206/Animal/M-series/World Formula Air Inlet Chamfer Clarification

Bulletin 2/23/17 – Non-impacting, Effective Immediately

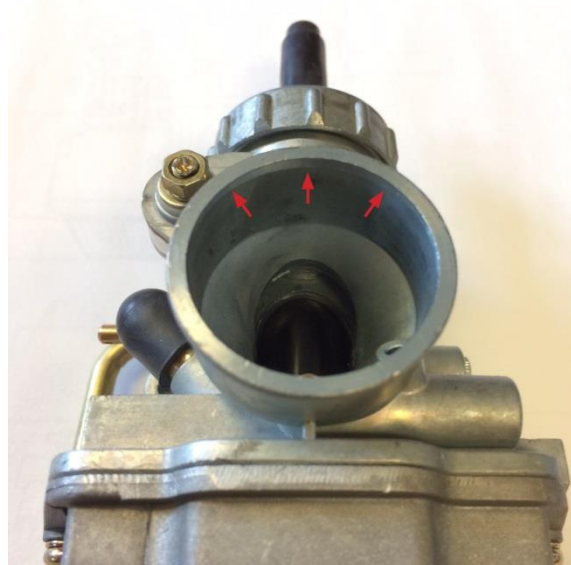
At the choke bore ID (sometimes referred to as the air horn) on the PZ22 and PZ26 a slight chamfer to remove any burrs left during facing of the inlet lip may be present. This is not new to the manufacturing of our carburetors but a recent concern and reason for this bulletin is that the finish appearance of this chamfer has changed.

The machining process of this chamfer now occurs after each carburetor body goes through a chemical bath to remove machining residue. This bath created the uniform coloring of the aluminum which previously minimized the visibility.

The PZ22 choke bore (air horn) has and will continue to remain subject to the 1.149" no go tech tool (A7).

18. Carburetor & Intake Manifold (2nd Paragraph): A slight chamfer around the choke bore ID (air horn) may be present. 1.149 no go **TECH TOOL A7**.
